Comments on the Portland Harbor Feasibility Study
By Environmental Stewardship Concepts, LLC
For the Willamette Riverkeeper and the Portland Harbor CAG
July 27, 2012

Figure 1. Minimum, mean, and maximum monthly Willamette River stage at Portland, Oregon from years 1973 through 2003. (US Army Corps of Engineers).

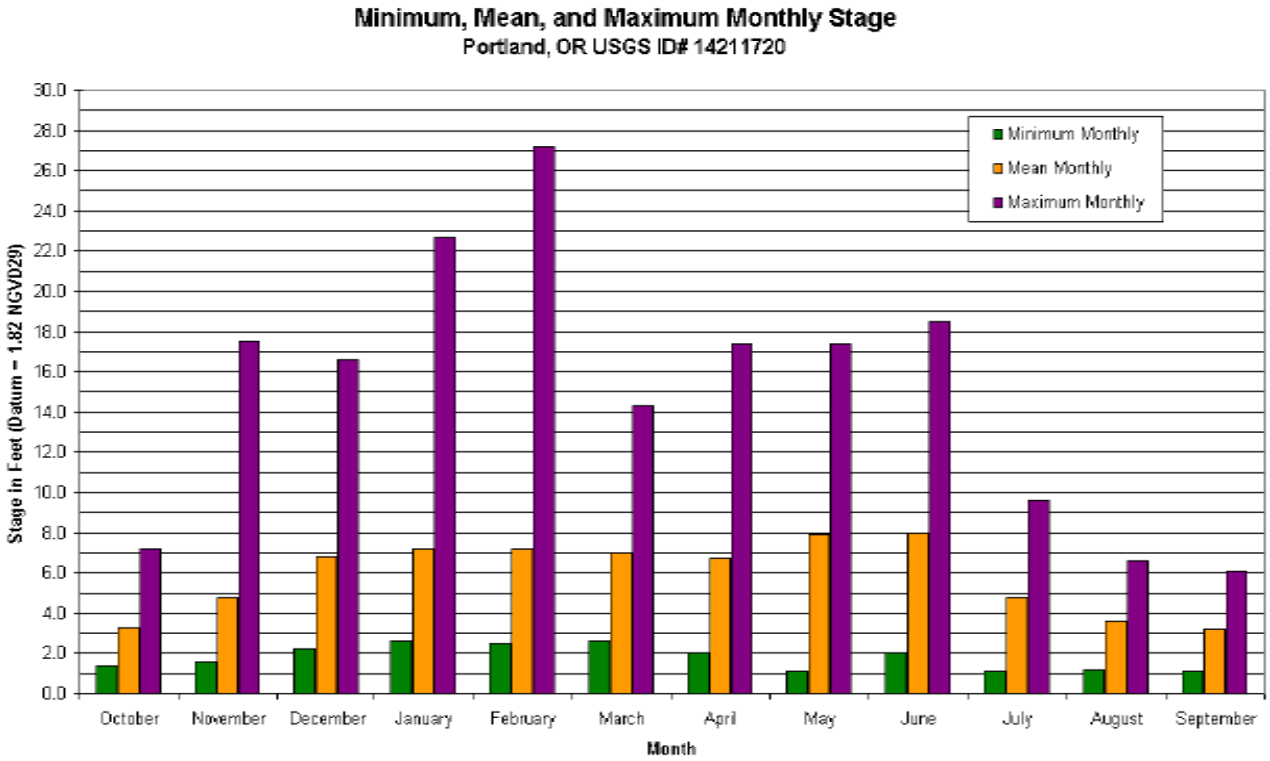
2. **Section 2.1.1** (Hydrology) states that, "*River stage and currents at the Site are influenced by hydrologic conditions in both the Willamette and Columbia Rivers, and are further affected by the operations of federal and non-federal dams along these two rivers, as well as tidal stages of the Pacific Ocean, which causes tidal fluctuations of up to a maximum of 3 feet per day throughout the Site*."

Relative to the tide difference, there is more than a 3 foot tidal fluctuation. Is the three feet only referencing the influence of the ocean tides on the fluctuations seen at Portland Harbor? USGS tides recorded at Morris Street Bridge show that an average tidal fluctuation in a day would not likely average to 3 feet.

Figure 2. Willamette River stage at Portland Oregon, from October 1, 1988 to June 8, 2012 (USGS)

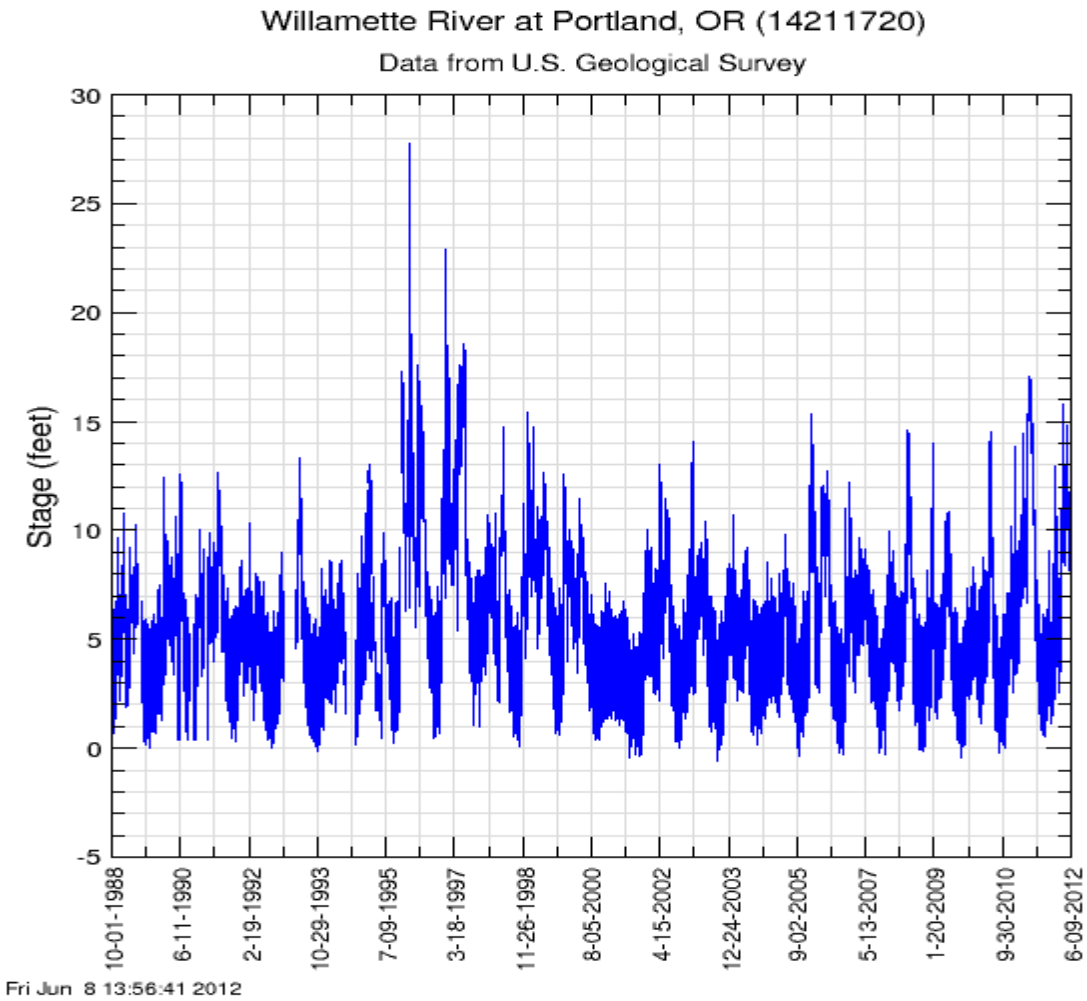
3. **Section 2.1.1** references past extreme flood events: "*The two highest peaks in the daily mean discharge record occurred during the winters of 1996 and 1997, when peak flows reached 420,000 cfs on February 9, 1996 and 293,000 cfs on January 2, 1997, respectively… As discussed in the draft final RI, unlike the Columbia River, the Willamette River flows generally increase in response to*

regional storms due to the comparatively small size of the basin. Record winter floods (e.g., 1964 and 1996) occurred when periods of heavy snowfall at lower elevations were followed by warming periods and heavy rains, resulting in rapid increases in runoff."

Have the alternatives been examined under conditions **more extreme** than these flood events? Any models using flow and river stage should incorporate the increasing occurrence and frequency of these events, as they are more likely a result of global warming. The following graph shows the Willamette River stage at Portland Oregon and the floods of 1996 and 1997.
